HISTORIC AND DESIGN REVIEW COMMISSION

July 19, 2023

HDRC CASE NO: 2023-262
ADDRESS: 250 LAUREL HEIGHTS PLACE
LEGAL DESCRIPTION: NCB 6327 B-2 L-28,29& E 45 OF 27,N 32.58 OF 57&58& N 32.58 OF E 45 FT OF 56 & BLK 2 LOT E TRI 4.16 FT OF 26 & W 5 OF 27 & W 5 OF N 32.58 FT OF 56
ZONING: R-5, H
CITY COUNCIL DIST.: 1
DISTRICT: Monte Vista Historic District
APPLICANT: Mauricio Tafoya/Leon Studio, LLC
OWNER: Benjamin Factor/MILLER S & FACTOR B
TYPE OF WORK: Construction of a 1-story, rear accessory structure
APPLICATION RECEIVED: June 30, 2023
60-DAY REVIEW: August 29, 2023
CASE MANAGER: Edward Hall
REQUEST:

The applicant is requesting a Certificate of Appropriateness for approval to construct a 1-story, rear accessory structure at 250 Laurel Heights Place, located within the Monte Vista Historic District. The proposed accessory structure is to feature 660 square feet.

FLOOR PLAN &
BUILDING ELEVATIONS

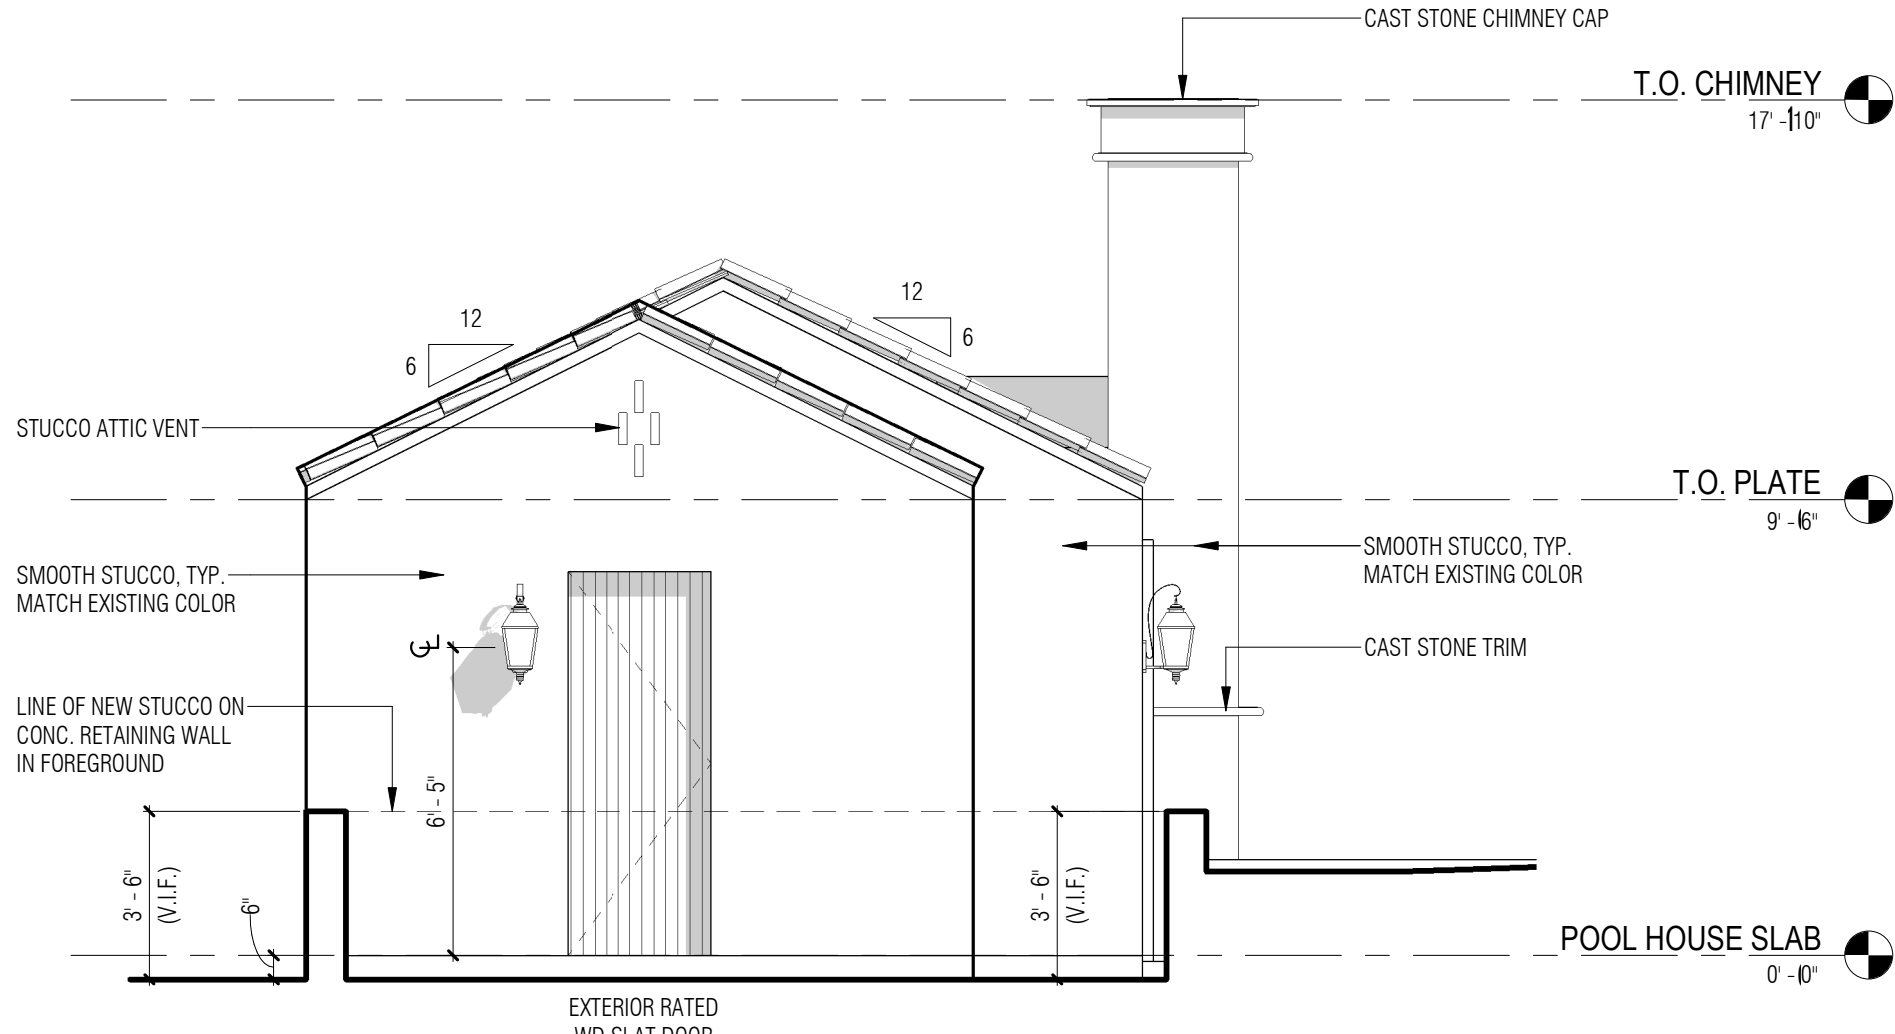
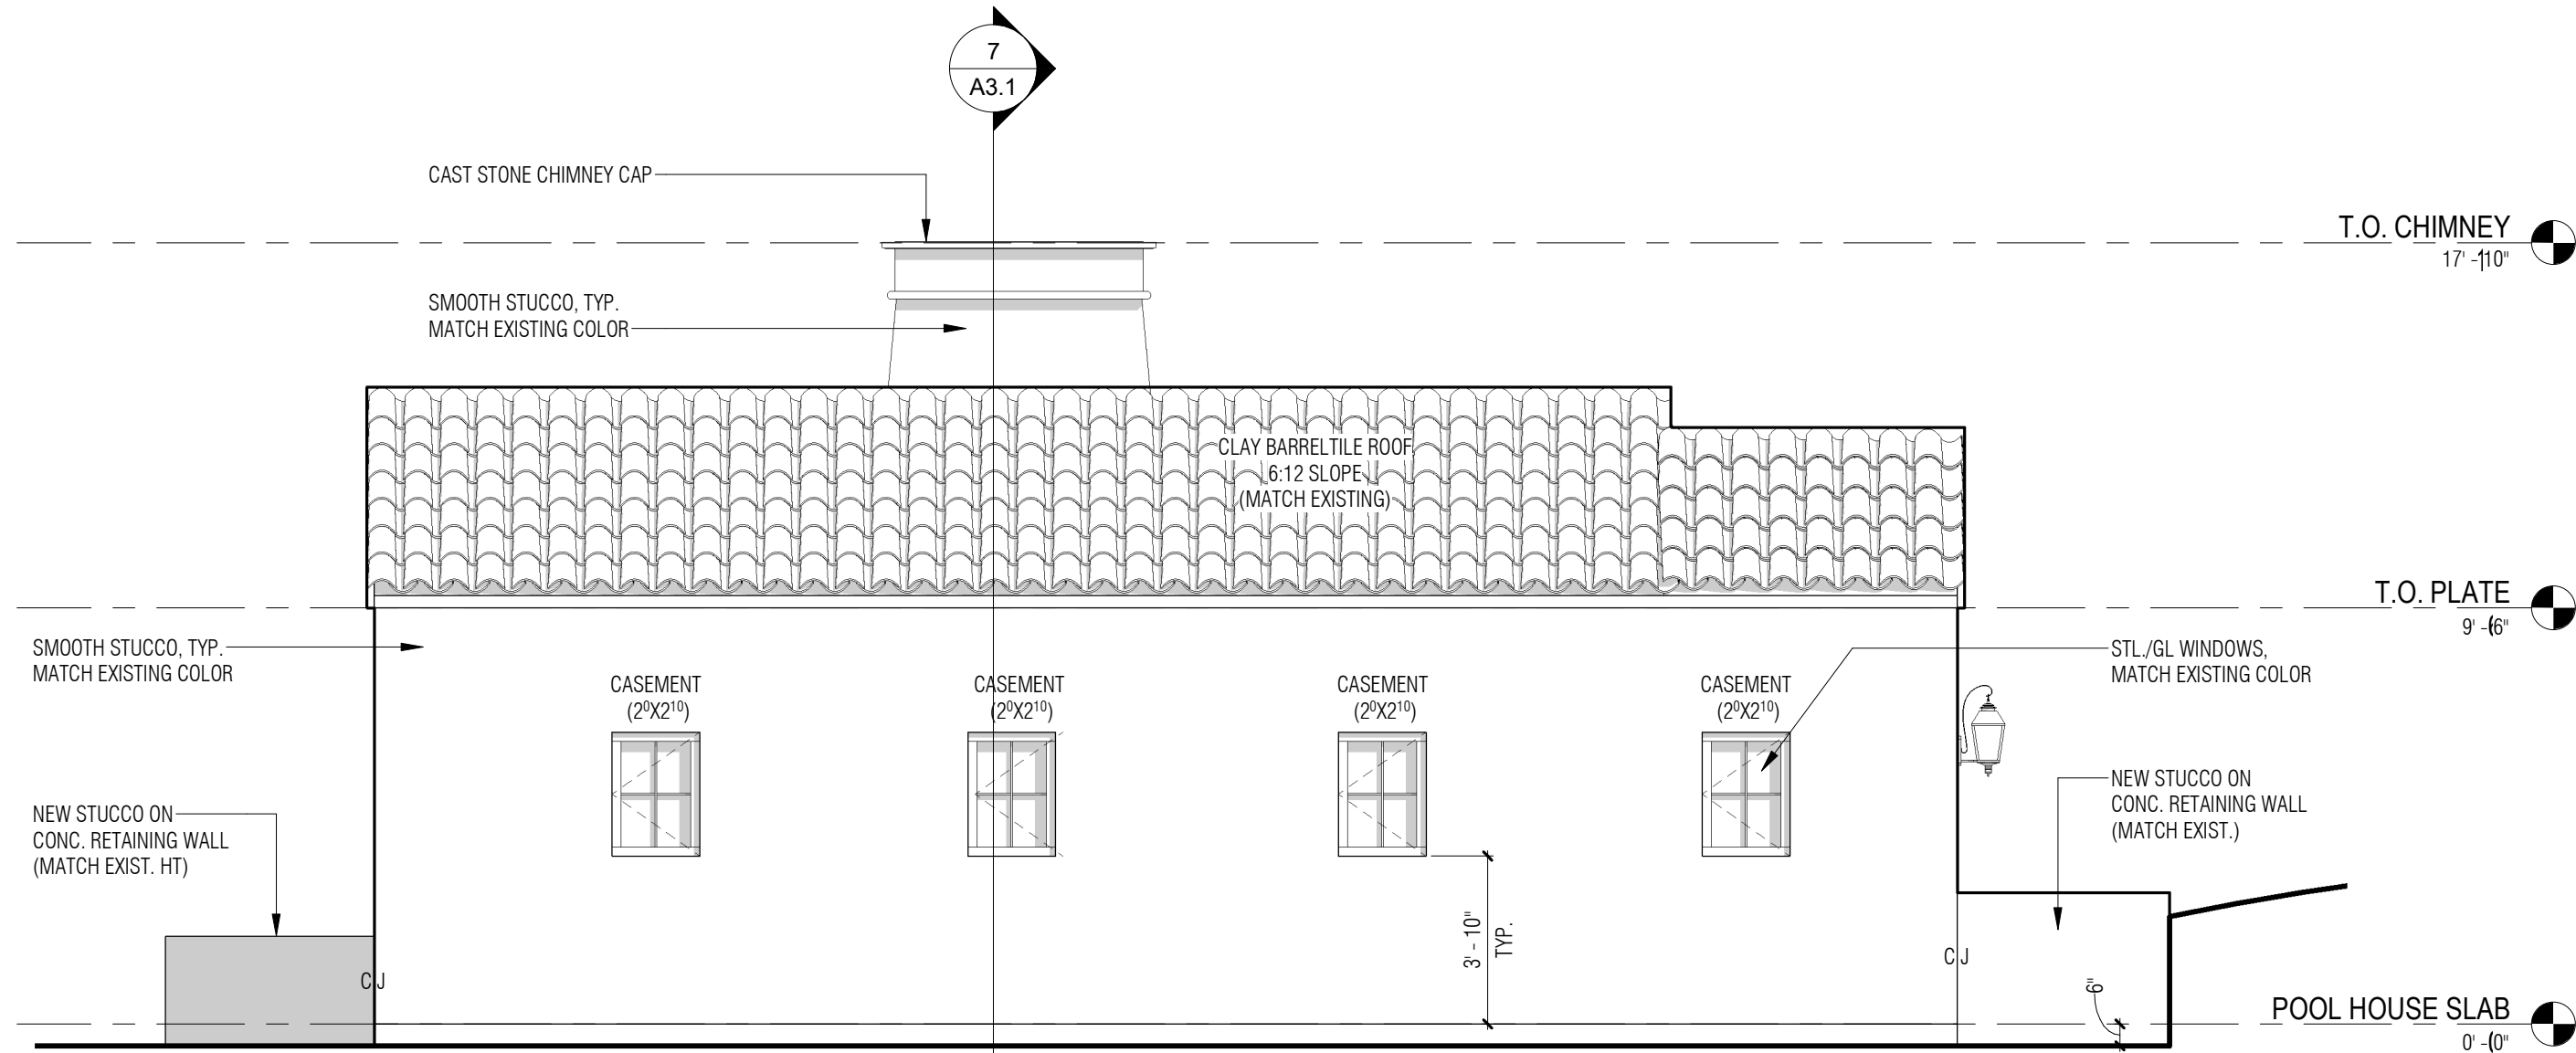
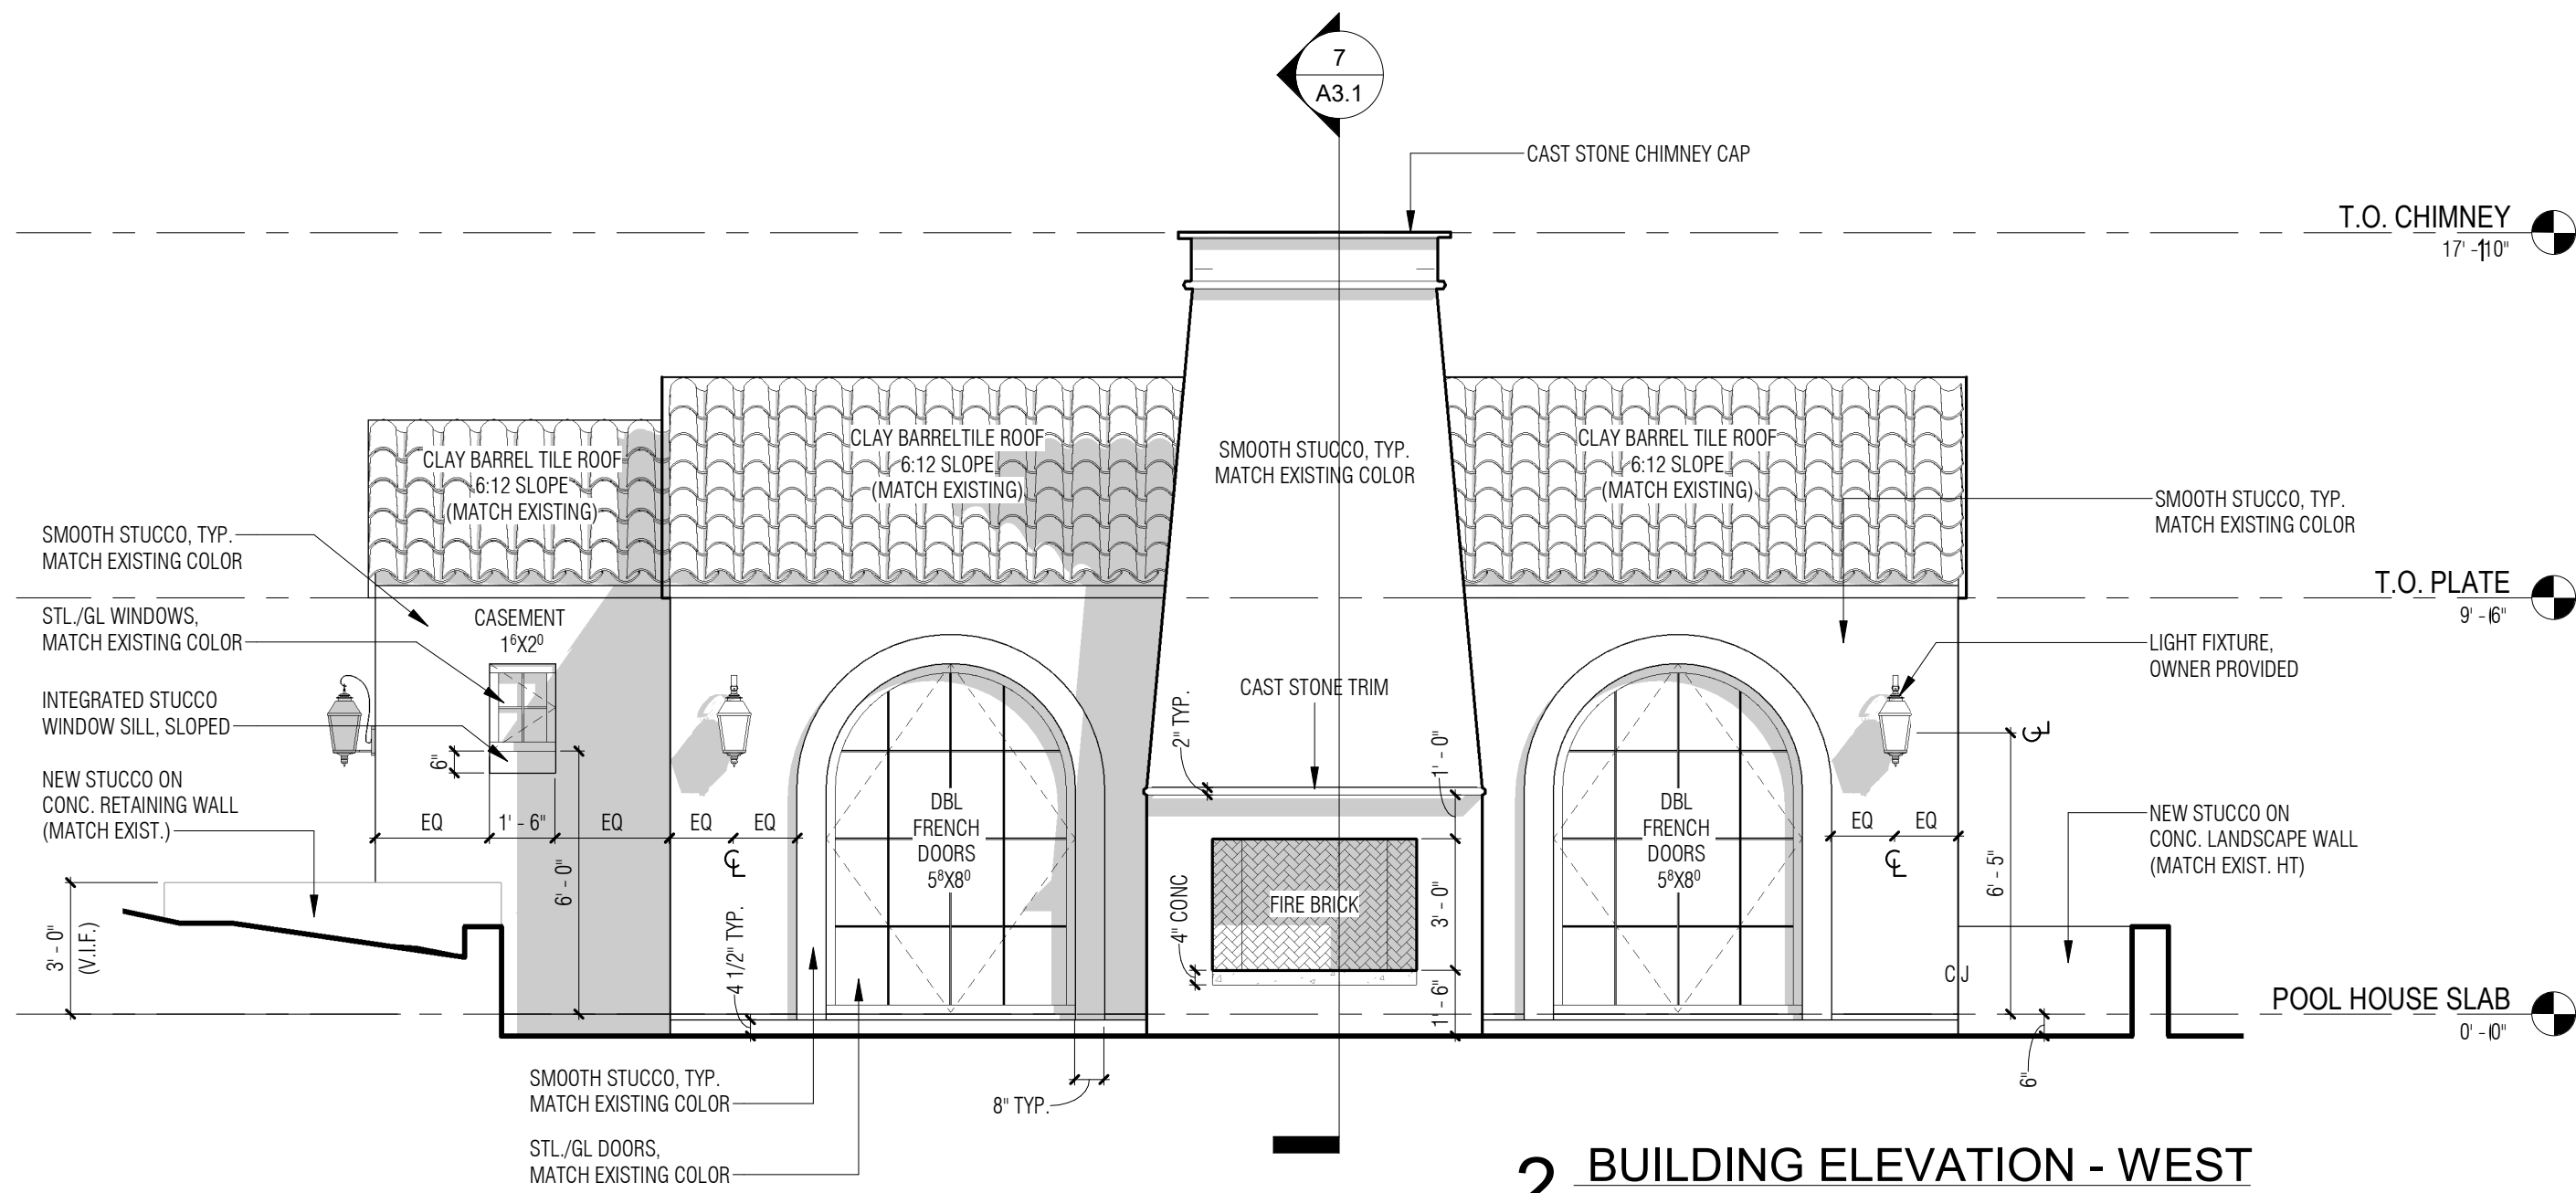
- d. **ACCESSORY STRUCTURE (Massing & Form)** – Regarding overall height, the applicant has proposed for the rear accessory structure to feature one story in height. Staff finds the proposed height to be appropriate and consistent with the Guidelines.

- e. **ACCESSORY STRUCTURE (Orientation & Setback)** – The Guidelines for New Construction 5.B. notes that the predominant accessory structure orientation and historic setback patterns of the block should be followed. Generally, staff finds the proposed location, orientation and setbacks associated with the proposed accessory structure to be appropriate and consistent with both the Guidelines and existing structure's location.

- f. **ACCESSORY STRUCTURE (Materials)** – The applicant has proposed materials that include a clay tile roof to match the existing, steel windows and doors to match those on the primary historic structure, and smooth stucco walls to match the finish of the stucco on the primary historic structure. Staff finds that the proposed steel windows should be consistent with the adopted policy guide regarding finish and installation depth. Windows should not feature faux divided lites or internal grilles.

- g. **ACCESSORY STRUCTURE (Architectural Details)** – The applicant has proposed an overall massing and form and materials that are generally consistent with the Guidelines and the historic architectural forms found both on site and throughout the district.

- i. That the proposed steel windows should be consistent with the adopted policy guide regarding finish and installation depth. Windows should not feature faux divided lites or internal grilles.
- ii. That product specifications be submitted to OHP staff for review and approval for the proposed roof tile and windows.
